WATTERS EDGE SUBDIVISION

Engineering Comments: FINAL PLAT COMMENTS (should be addressed prior to submitting the FINAL PLAT for review and/or signature by the City Engineer):

APPLICATION NUMBER 5 DATE October 19, 2017

DETAIL SITE PLAN

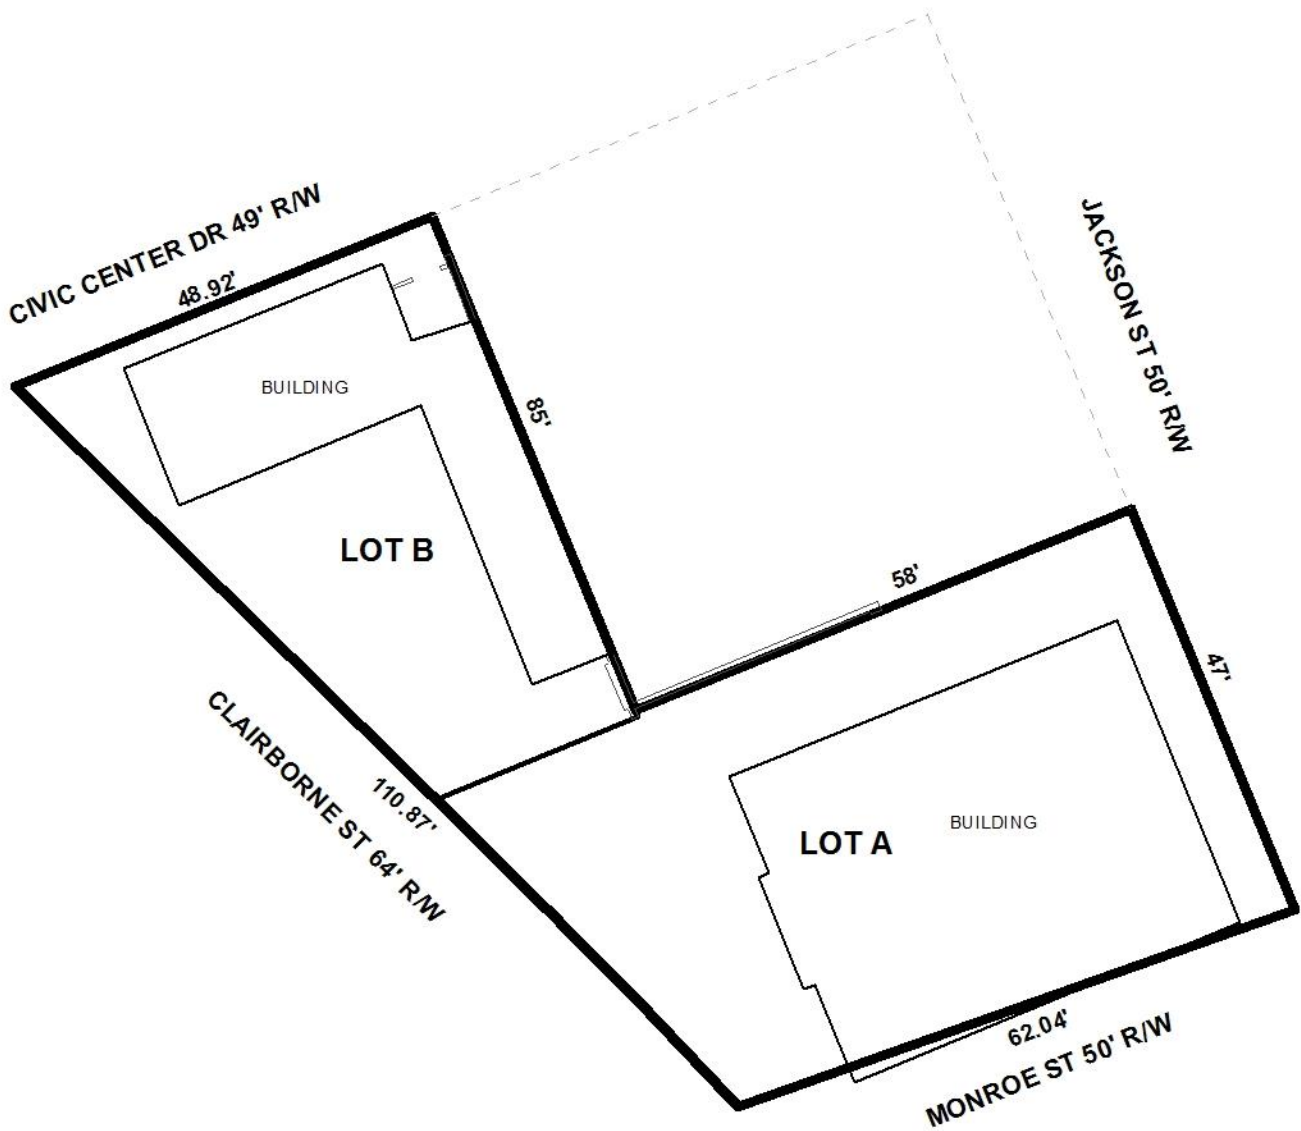
- A. Provide all of the required information on the SUBDIVISION PLAT (i.e. signature blocks, signatures, certification statements, written legal description, required notes, legend, scale, bearings and distances) that is required by the current Alabama State Board of Licensure for Professional Engineers and Land Surveyors.

- B. Revise the plat to label each lot with its size in acres and square feet, or the furnishing of a table on the Plat providing the same information.

- C. Dedicate the corner radius (25' minimum or as approved by the City Engineer and Traffic Engineer) at the northwest corner of LOT B, and southeast and southwest corners of LOT A.

- D. Show and label all flood zones.
- E. Show and label the MFFE (Minimum Finished Floor Elevation) on each lot that contains an AE, V, or X (shaded) flood zone designation.

- F. Provide and label the monument set or found at each subdivision corner.
- G. Add a signature block for the Owner, Notary Public, Planning Commission, Traffic Engineer, and City Engineer.

There are no building setback lines illustrated on the preliminary plat. The DDD, per Section 64-3.I.8.(d), allows from 0' minimum to 12' maximum setback along all street frontages. If approved, the Final Plat should be revised to illustrate a 12' maximum building setback line along all street frontages, with a note stating a 0' minimum is allowed.

The DDD requires a parking setback of at least the building setback for T-5.2 Sub-districts per Section 64-3.I.8.(d) of the DDD code. If approved, a note should be placed on the Final Plat indicating that a parking setback of at least the building setback is required.

The proposed lots do not meet the 7,200 square foot minimum lot size requirements of Section V.D.2. of the Subdivision Regulations for lots served by public water and sanitary sewer systems. However, the preliminary plat does not provide the lot sizes in square feet. If approved, the lot size information should be provided in both square feet and acres on the Final Plat. However, there is no minimum lot area requirement for lots within the DDD.

- 1) Retention of the labeled right-of-way widths for all abutting streets;
- 2) Illustration of a 12' maximum building setback line along all street frontages, with a note stating that 0' minimum building setback is allowed;

- 3) Provision of lot size information in both square feet and acres;
- 4) Placement of a note on the Final Plat stating that each lot is limited to one curb cut per street frontage, with size, location and design to be approved by Traffic Engineering and conform to AASHTO standards.
